U.S. DEPARTMENT OF TRANSPORTATION
FEDERAL HIGHWAY ADMINISTRATION
EASTERN FEDERAL LANDS HIGHWAY DIVISION

Amendment No. 002
Natchez Trace Parkway
Project PRA-NATR 3D30,E12
DTFH71-08-B-00003

The purpose of this Amendment is to:

DETAIL
 E635-A

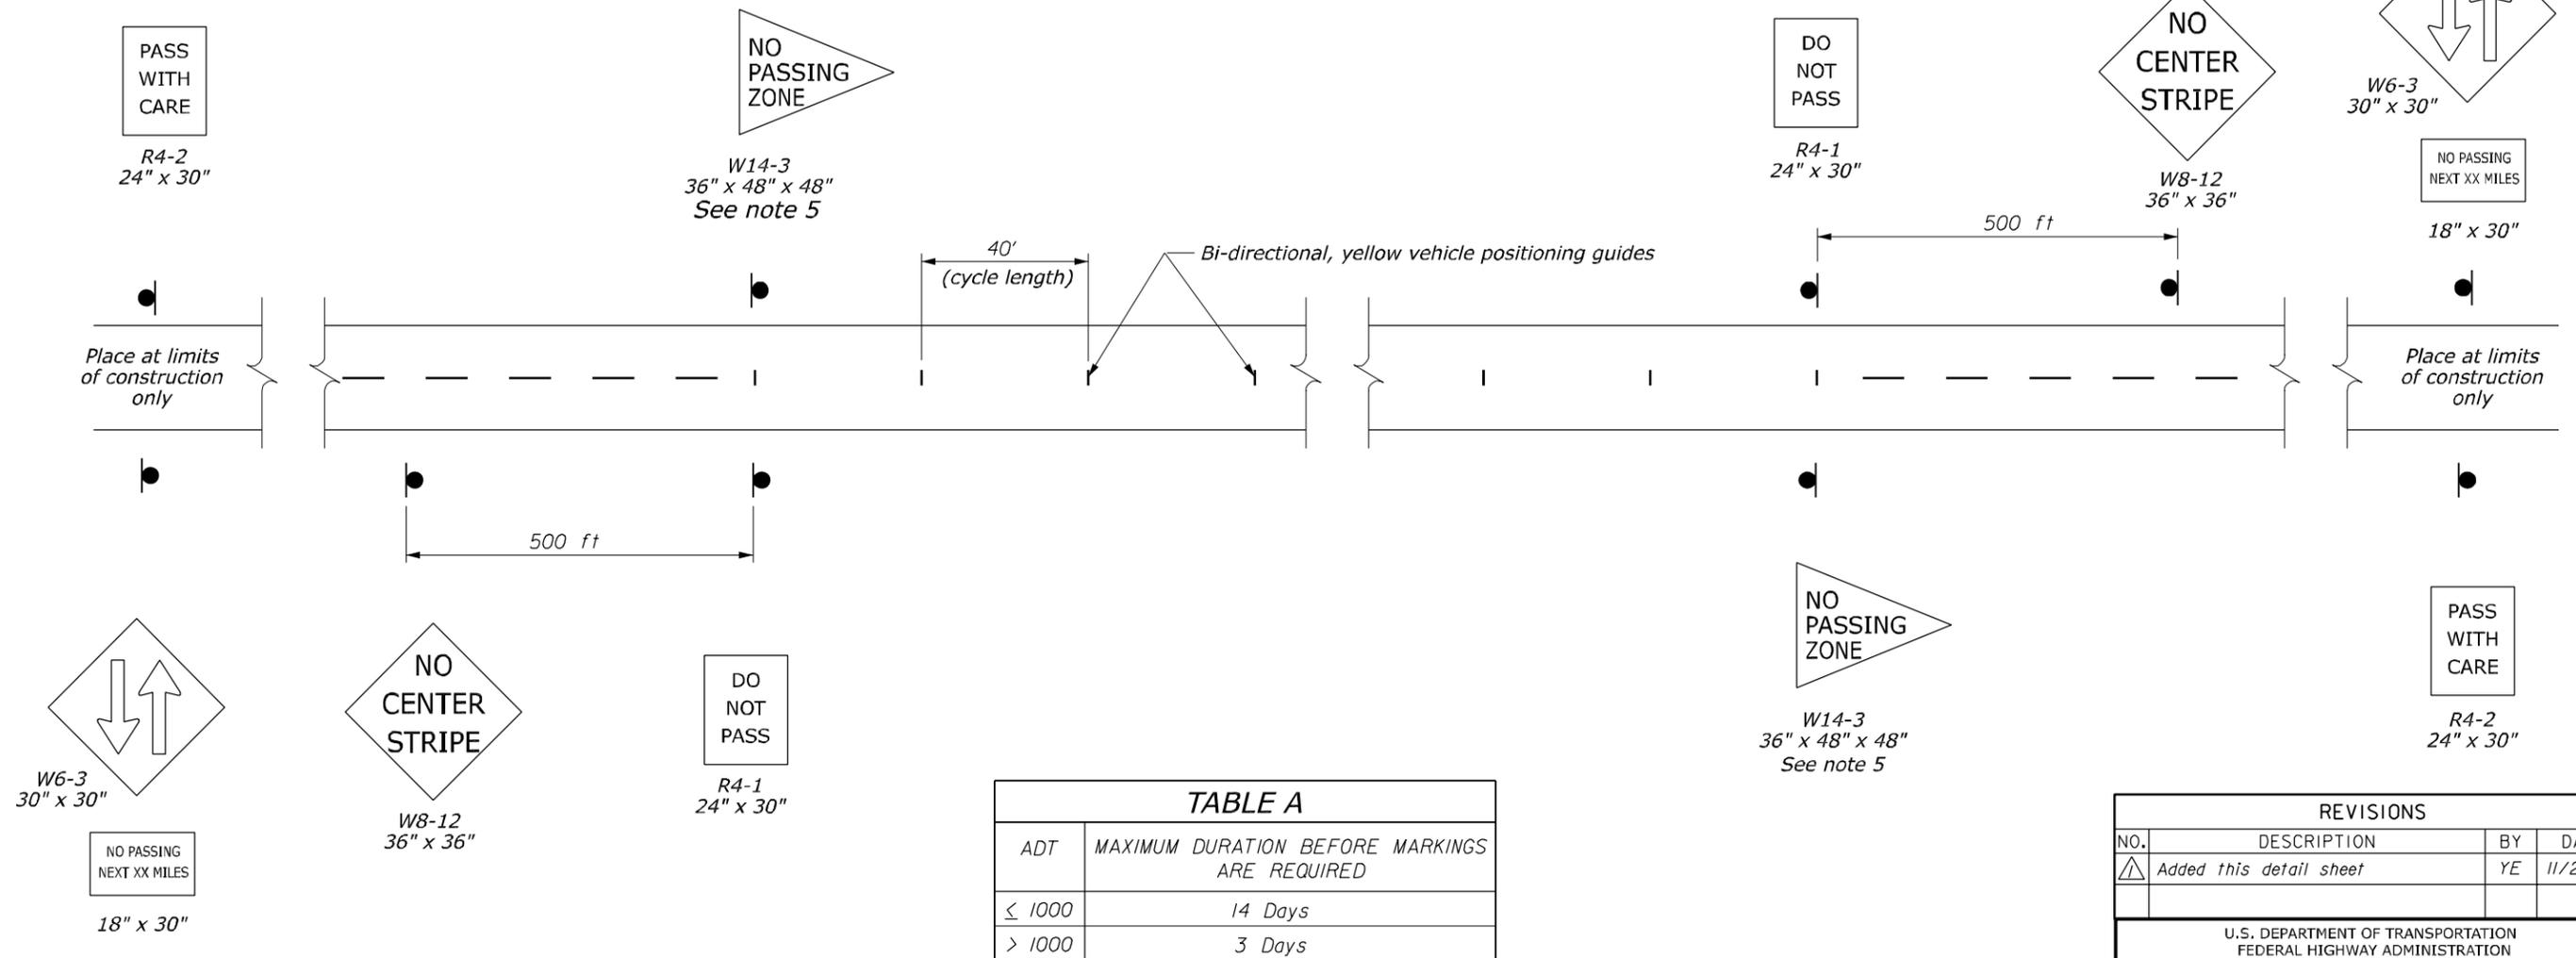
Install temporary pavement markings for the centerline. Do not install temporary pavement markings for the edgelines. If temporary raised pavement markers are used, install per Detail E635-A.

1. *Add Plan Sheet S-30.*
